Reds PCB_DM3730.PrjPCB	
DM3730_POWER.SchDoc	Rev 0.5
Drawn by: ONH	Date: 10.10.2012
Approved by: *	Page 18 of 28

Reds PCB_DM3730.PrjPCB	
DM3730_SDCARD.SchDoc	Rev 0.5
Drawn by: ONH	Date: 10.10.2012
Approved by: *	Page 19 of 28

RODS PCB_DM3730.PrjPCB	
DM3730_ETHERNET.SchDoc	Rev 0.5
Drawn by: ONH	Date: 10.10.2012
Approved by: *	Page 20 of 28

1V8 processor board source voltage selection

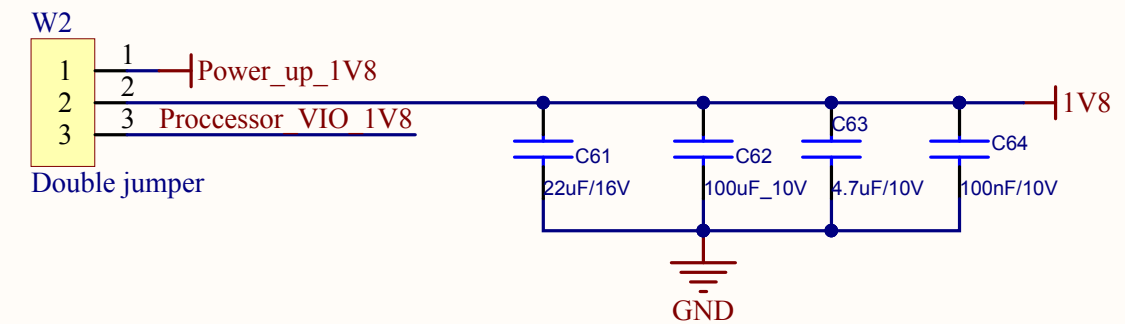
Question (03.10.2012)
Est-il nécessaire de garder cette fonctionnalité ?

MICROPHONE

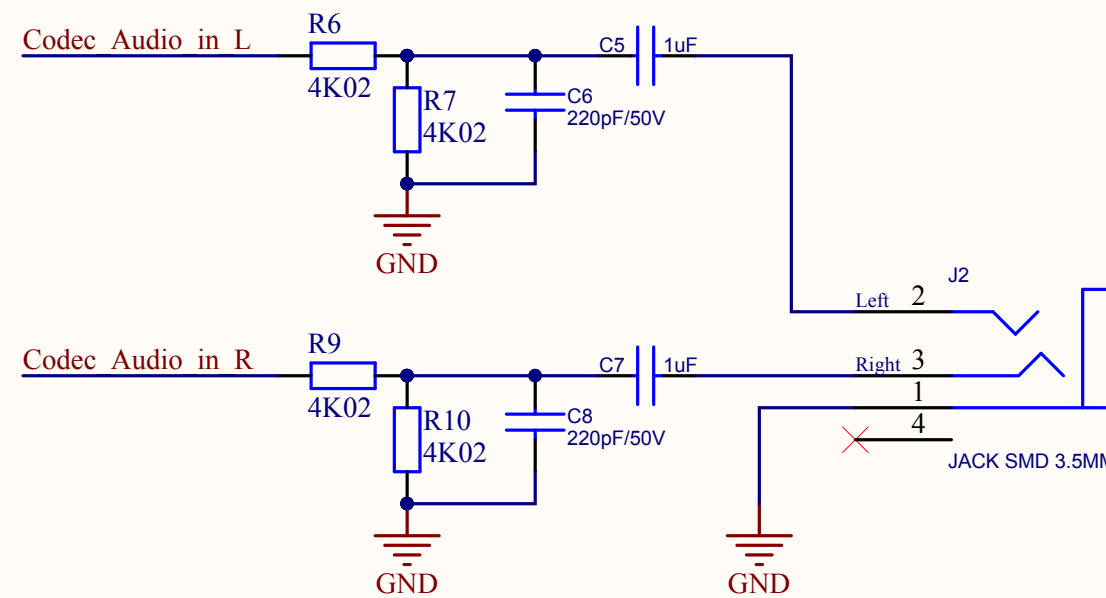
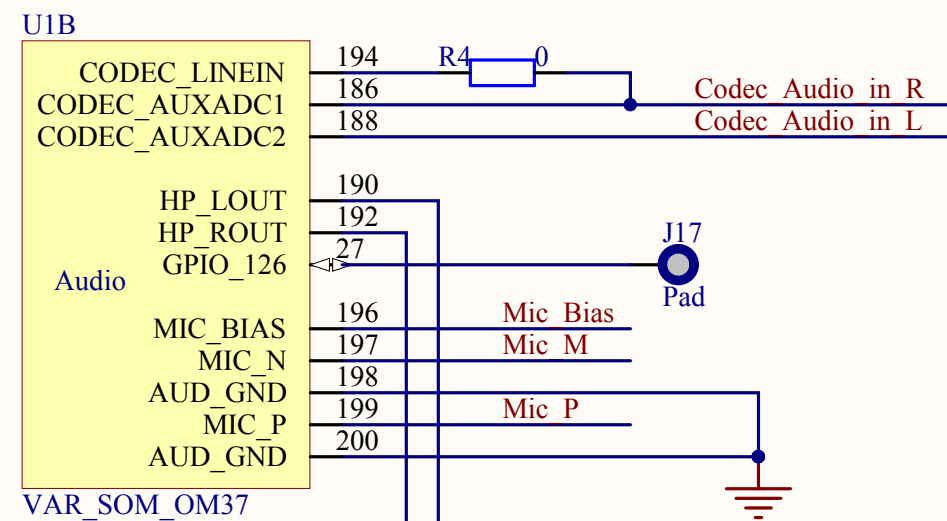
Le blindage du chemin MIC et AUDIO IN a été amélioré au niveau du PCB - A valider

AUDIO OUT

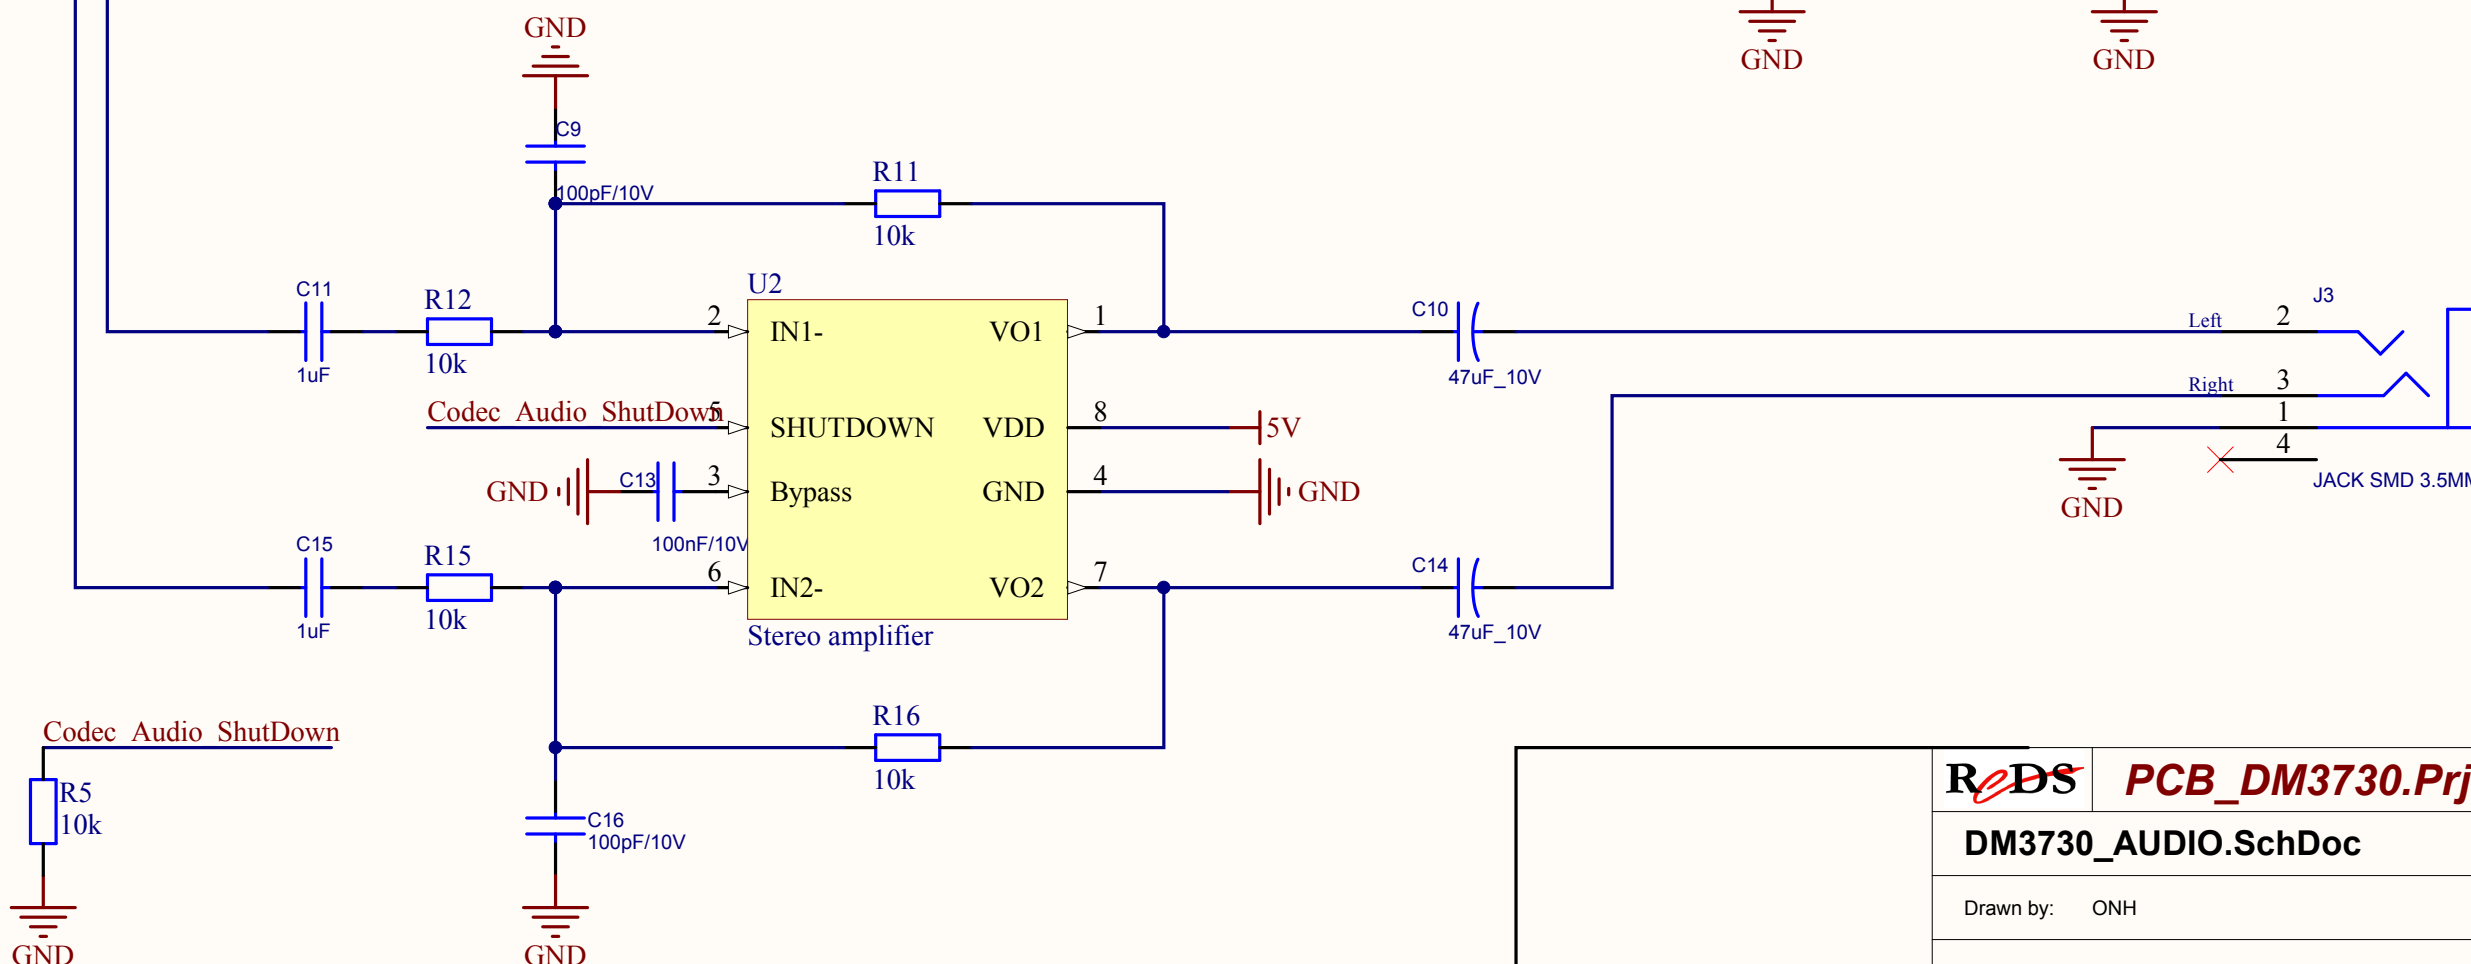
Decouplage A placer vers U2

Reds PCB_DM3730.PrjPCB	
DM3730_USB_HUB.SchDoc	
Drawn by: ONH	Rev 0.5
Approved by: *	Date: 10.10.2012
	Page 22 of 28

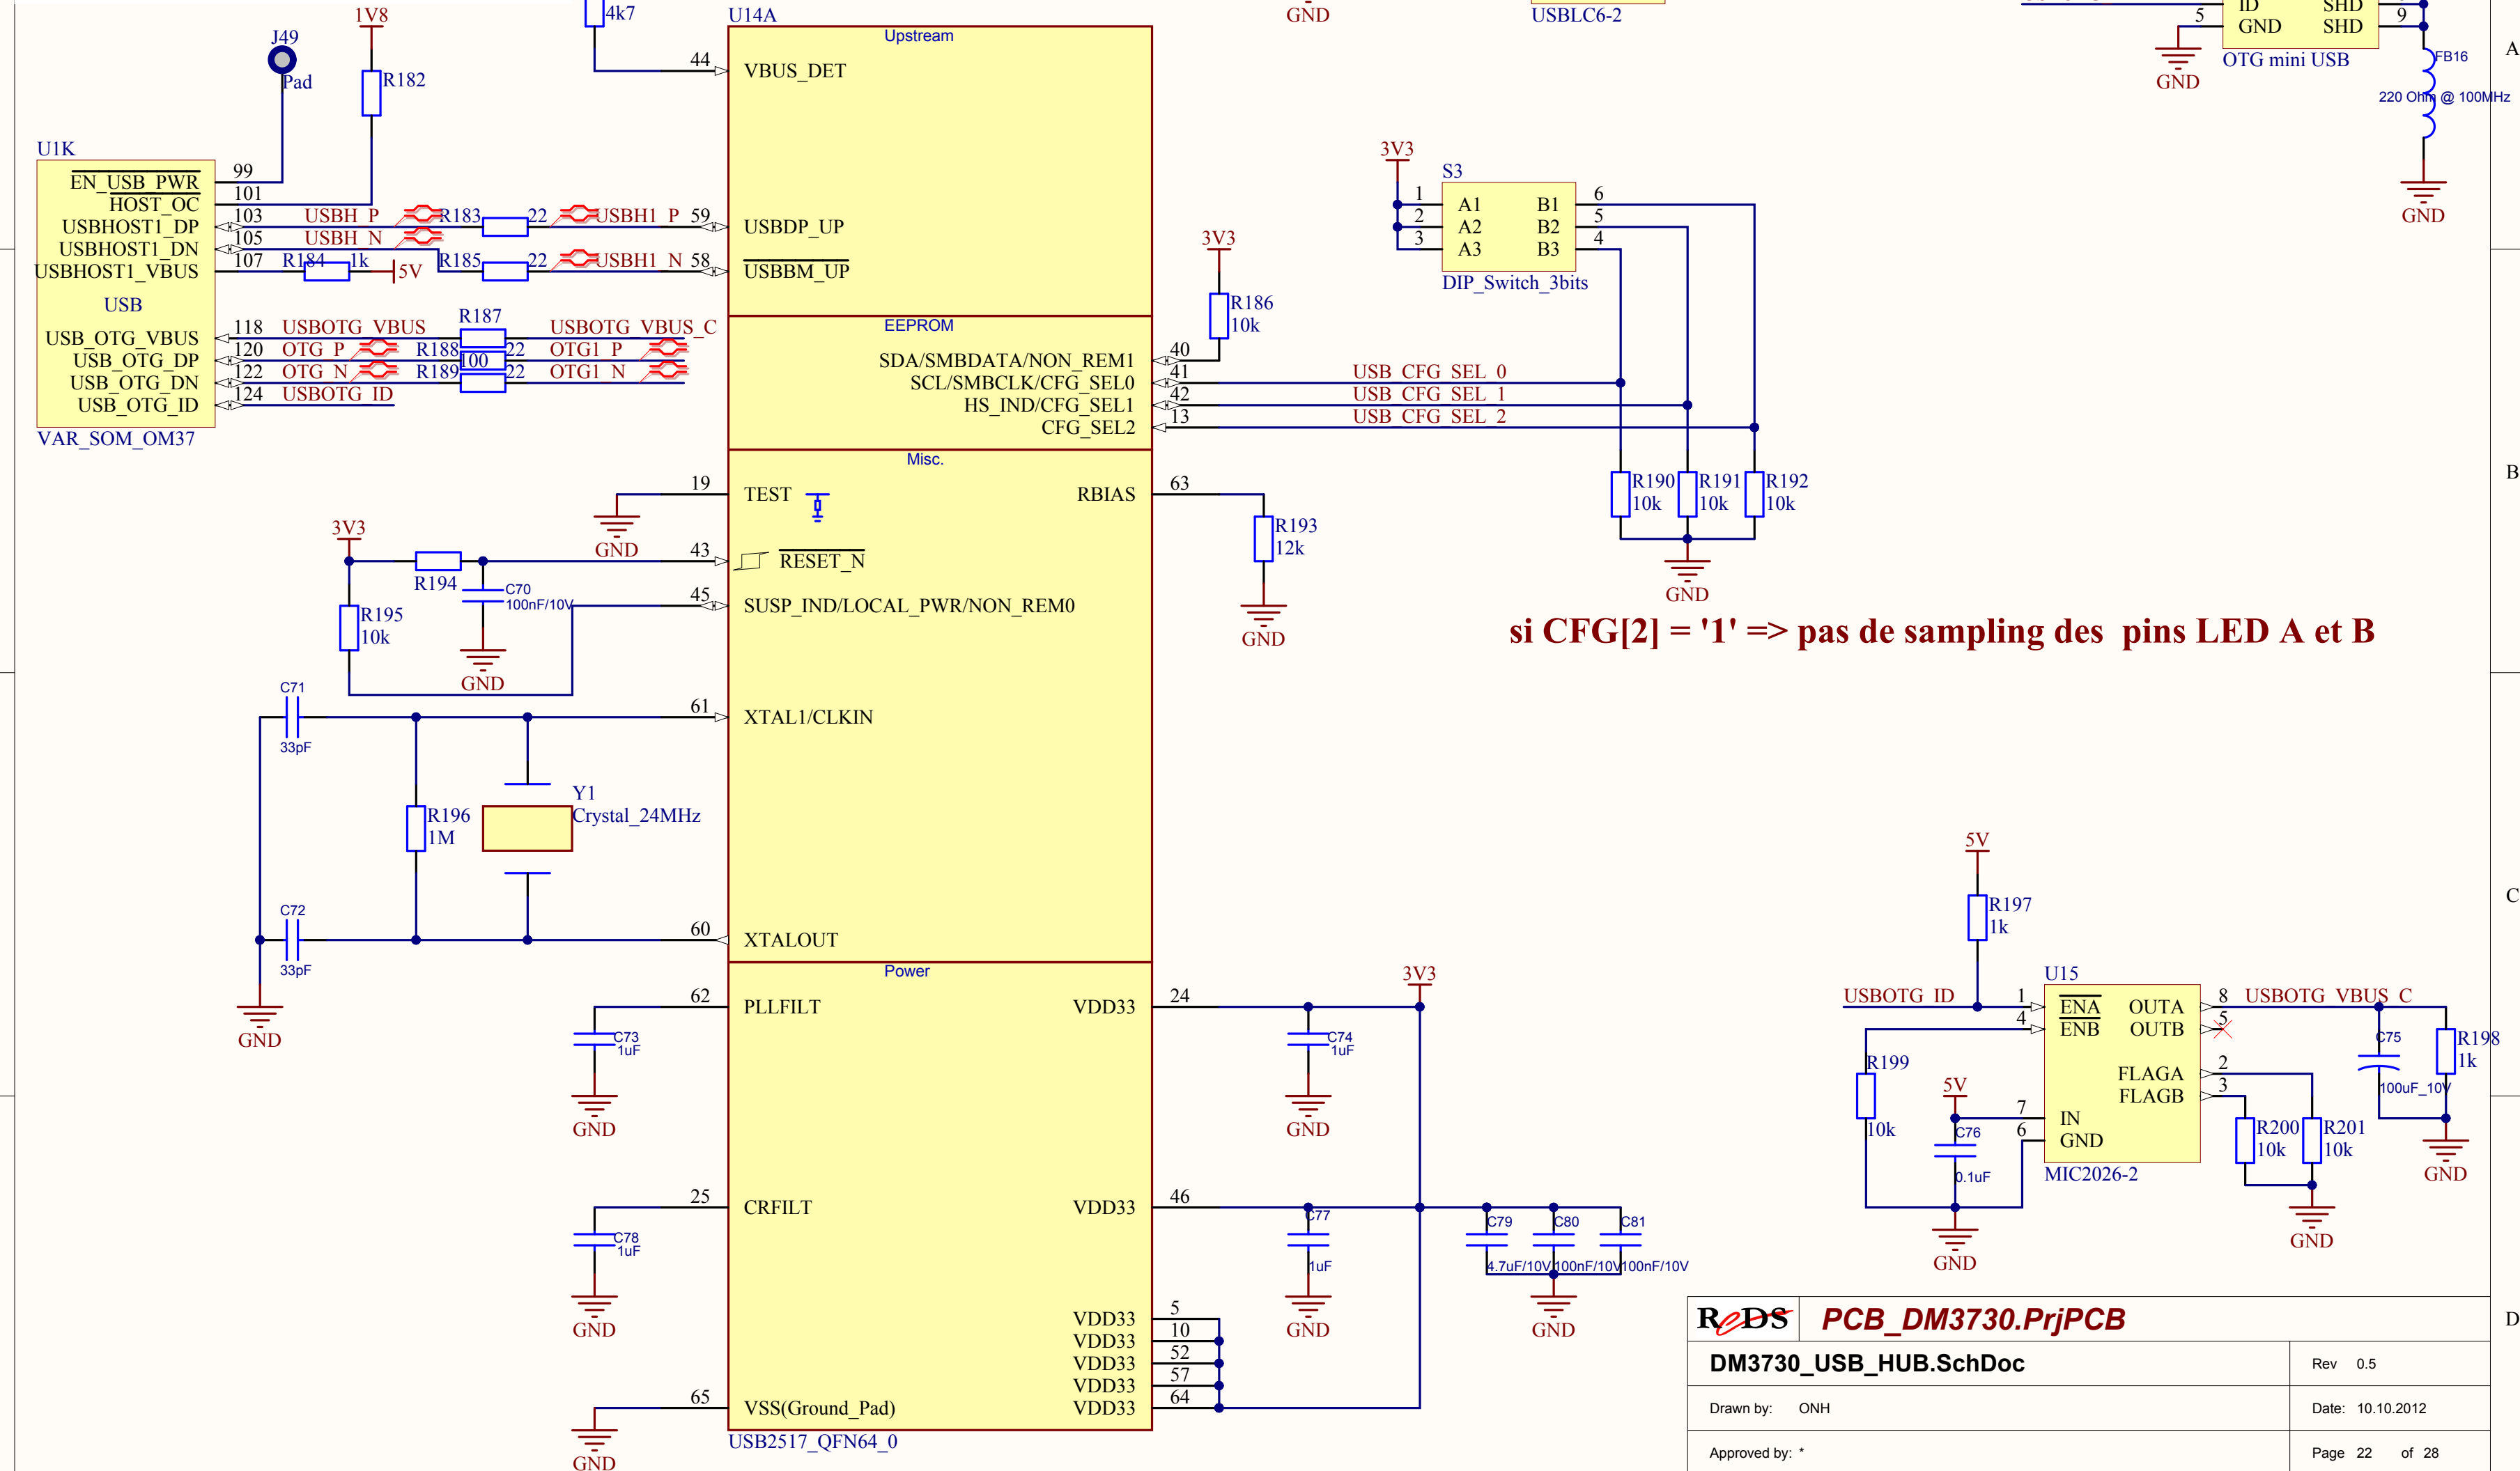
**NOTE: OTG fonctionne en mode Device -
Testé et validé. En mode Master, pas validé et
fonctionnalité supprimée des spec.
=> A supprimer dans Datasheet**

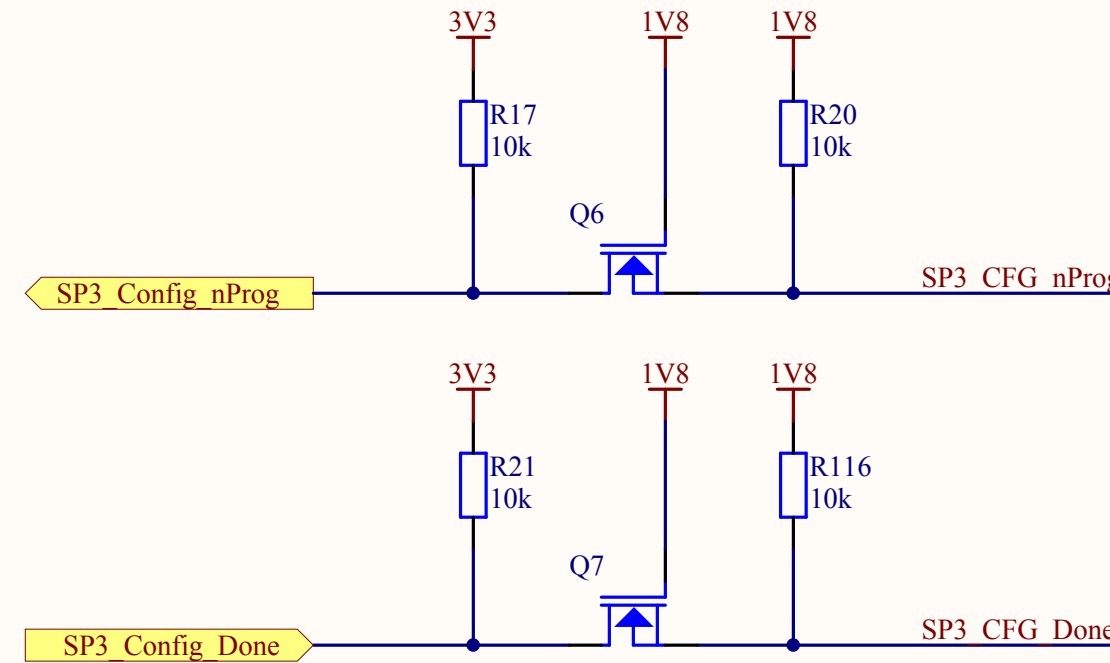
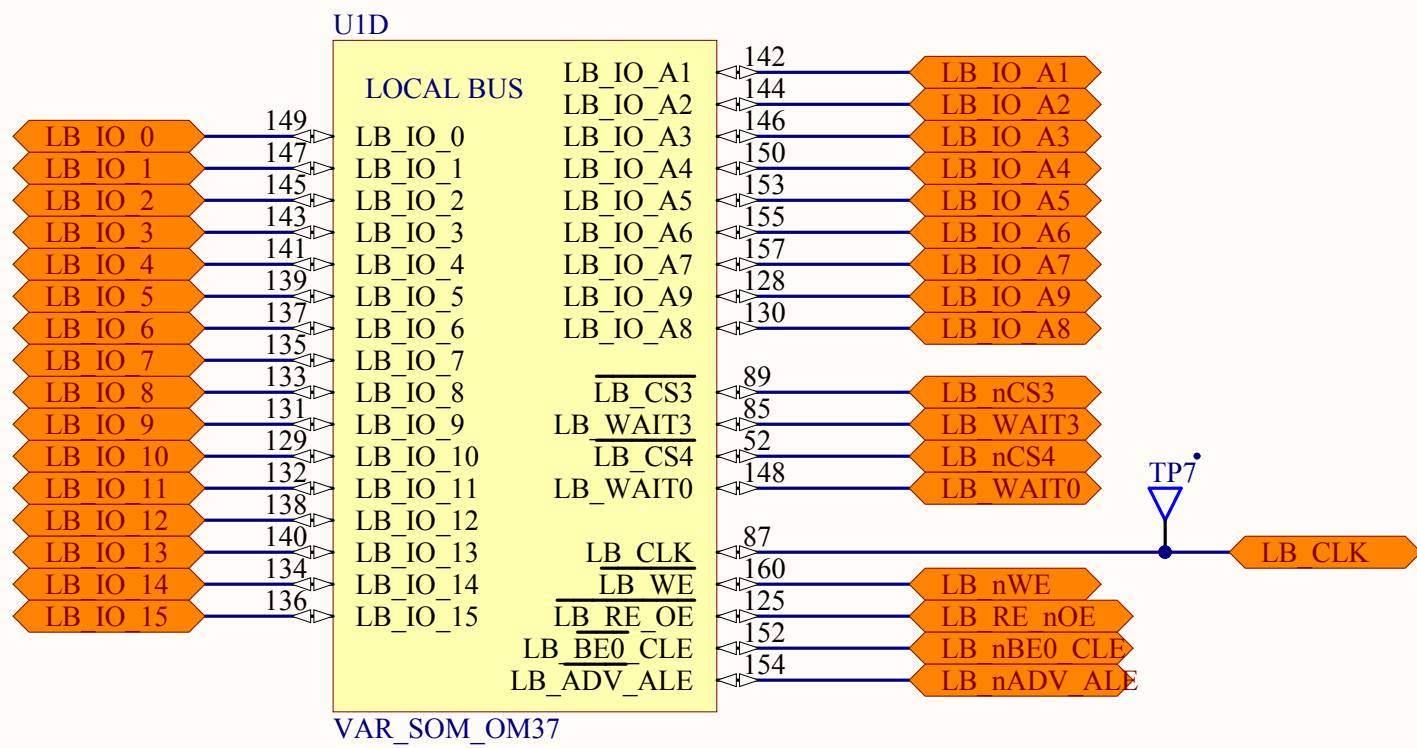
D15 à D17 à remplacer par res 10K (0402) Ticket 614 - OAN (06.09.2012)

Ticket 614 - clos - 03.10.2012 - pas de modification nécessaire (problème résolu avec jumper HSWAPEN)

Connecteur Ribbon -> PCB FPGA

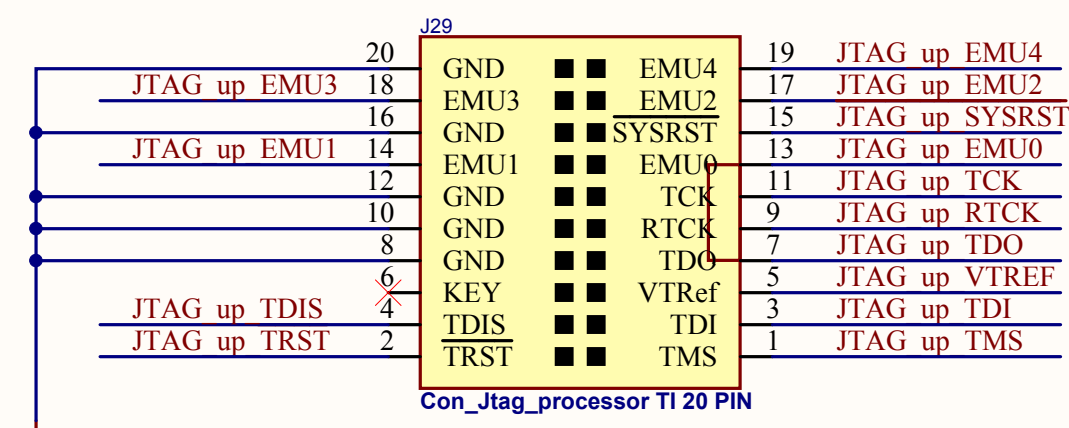
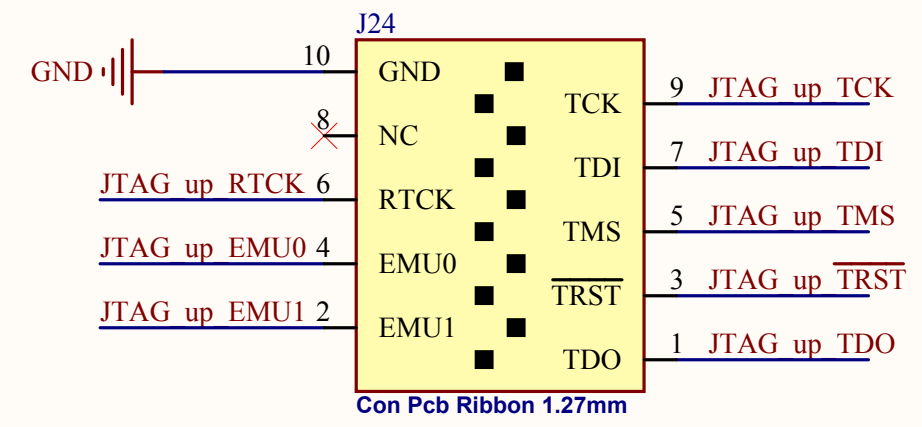
Ticket 601 - Détrompeur - Couper pin 6 sur carte CPU
A mettre dans rapport à Locatis (TODO)
